Access Compliance Report

Public Rights-of-Way

(Curb Ramps)

Intersection ID: 15542	Main Street: CLANTON_RD	Cross Street: N_I-77_TO_CLANTON_RD_RA	Location: S
ADA ID: 17C0C43C605D	Ramp Type: Perp	Initial Pass/Fail: Fail	Overall Compliance: No
Severity Score: 21.25			
Codes/Mitigation Info/Possible Solution		Field Measurements/Component Compliance

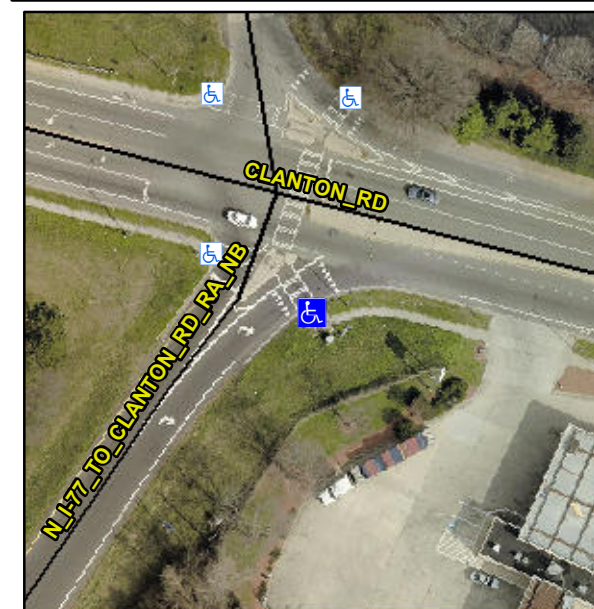
Not Found, R304.5.1, R304.5.3

Compliance	Description	Data	Compliance	Description	Data
N/A	Ramp Length (in)	92.0	Yes	Ramp Slope (%)	6.2
No	Ramp Width (in)	46.5	No	Ramp XSlope (%)	5.3
N/A	Flare Type LT	N/A	N/A	Flare Type RT	N/A
N/A	Flare Slope LT (%)	N/A	N/A	Flare Slope RT (%)	N/A
N/A	Flare Traversable LT?	N/A	N/A	Flare Traversable RT?	N/A
N/A	Landing Length (in)	N/A	N/A	DWS Provided?	N/A
N/A	Landing Width (in)	N/A	N/A	DWS Contrast?	N/A
N/A	Landing Slope (%)	N/A	N/A	DWS Length (in)	N/A
N/A	Landing X Slope (%)	N/A	N/A	DWS Full Width?	N/A
N/A	Landing Curb? (Y/N)	N/A	N/A	DWS Offset (in)	N/A
N/A	Shared Landing?	N/A			
N/A	Gutter Ponding?	N/A	N/A	Gutter Slope (%)	N/A
N/A	Gutter Lip Ht (in)	N/A	N/A	Gutter X Slope (%)	N/A
N/A	Painted X Walk1?	Yes	N/A	Painted X Walk2?	N/A
	X Walk 1 Direction	To NW		X Walk 2 Direction	N/A
N/A	X Walk 1 Width (in)	112.0	N/A	X Walk 2 Width (in)	N/A
	X Walk 1 Slope (%)	3.8		X Walk 2 Slope (%)	N/A
	X Walk 1 X Slope (%)	2.8		X Walk 2 X Slope (%)	N/A

Remove & Replace Entire Ramp.
